Work Order ID 139689

Item Name: Quick Release Heli-Utility-Basket™ Long, HD Lid, Spacepod™/Squirrel Cheek Comp.

DART SERVICE INSTRUCTION

TO AMEND INSTALLATION INSTRUCTIONS D350-607-3 Rev.D,
INSTALLATION INSTRUCTIONS D350-607-4 Rev. C AND
INSTRUCTIONS FOR CONTINUED AIRWORTHINESS ICA-D350-607 REV. 6
REF TCCA STC: SH94-14
REF FAA STC: SR00213NY
REF EASA STC: EASA.10016996
REF BRAZILIAN STC: 2007S03-03/-04/-05/-06

FIGURE 1: INSTALLATION OF D4775-041 FWD STRUT

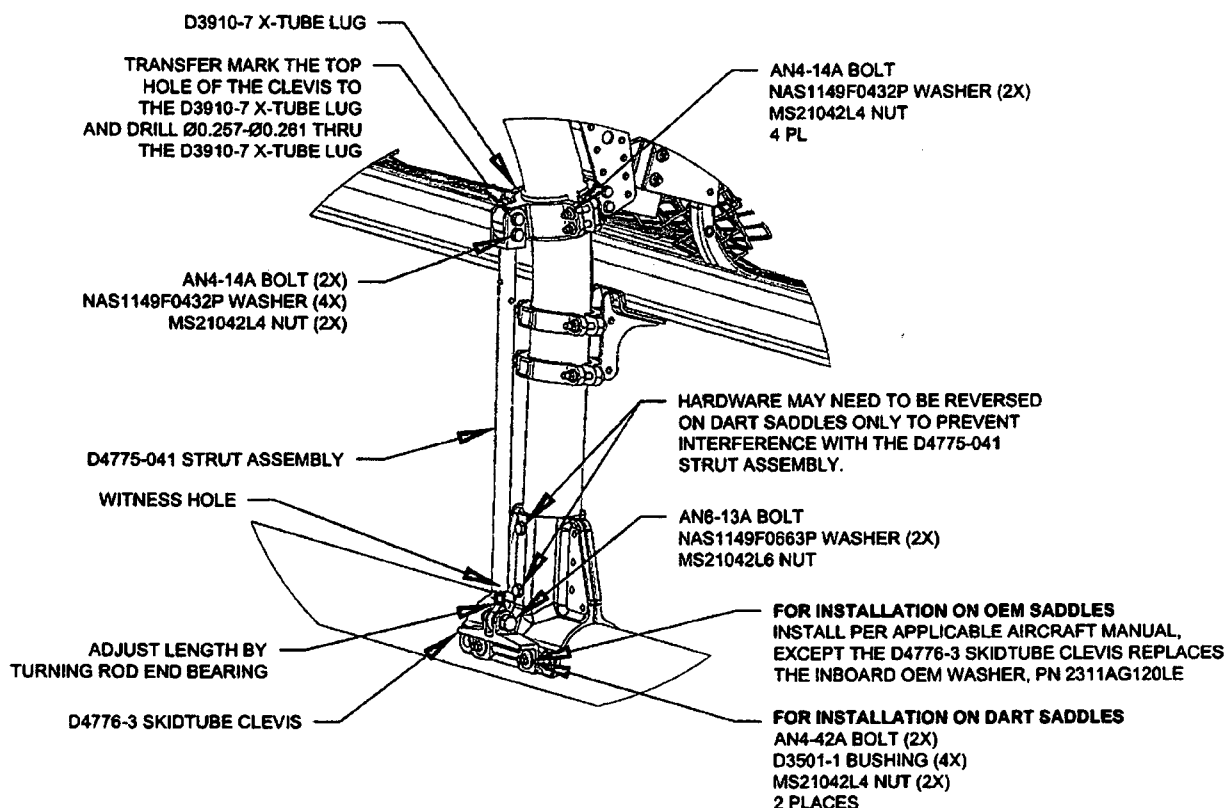
- 3.1 Substitute the Forward Lower D3910-5 X-Tube Lug with the D3910-7 X-Tube Lug as shown in Figure 1.
- 3.2 Install the forward D4775-041 Strut Assembly. Transfer mark from the upper hole on the clevis of the D4775-041 Strut Assembly to the D3910-7 X-tube Lug and drill thru the lug $\varnothing 0.257 - \varnothing 0.261$ as shown in Figure 1. Touch up chemical conversion coating per MIL-DTL-5541. Check the witness holes located at the bottom end of the D4775-041 Strut Assemblies to ensure that the thread from the rod end extends past the witness hole.
Torque MS21042L4/-4 nuts to 50-70 in-lbs (5.7-7.9 N-m). Torque MS21042L6/-6 nuts to 160-190 in-lbs (18.1-21.5 N-m).
- 3.3 Complete the installation in accordance with Installation Instructions D350-607-3 Rev. D or D350-607-4 Rev. C.
